PCI 9030AA Data Book Addendum

A. Affected Silicon Revision

Product	Revision	Description	Status
PCI 9030	AA	PCI SMARTarget I/O Accelerator	Production

18. Figure 13-2 Land Pattern Dimensions

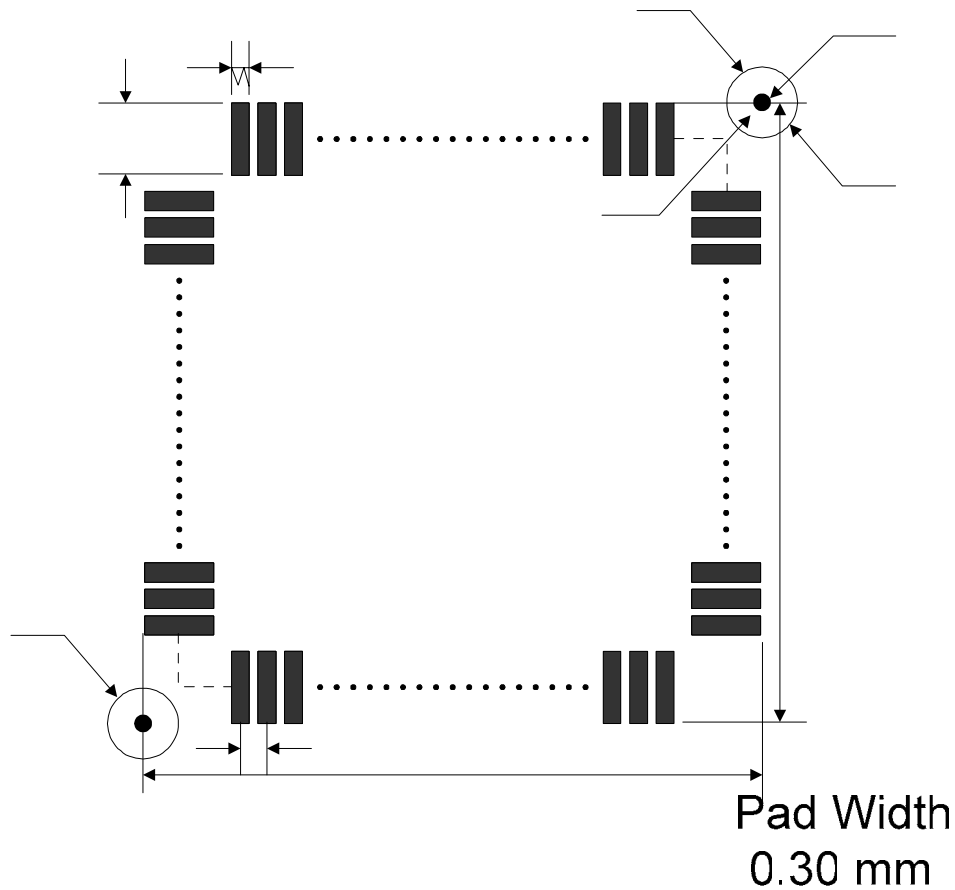
The *PCI 9030 Data Book*, v1.4, Figure 13-2, “176-Pin PQFP PCB Layout Suggested Land Pattern,” on page 13-2, indicates incorrect dimensions. The following table lists the old and new values, and the illustration replaces the current Figure 13-2.

Figure 13-2 Label	Old Value	New Value
Pad Width	0.3048	0.30
Pad Length	1.524	1.50
Metal Pad	1.016	1.00
A	27.178	27.18
B	27.178	27.18

Pad Length
1.50 mm
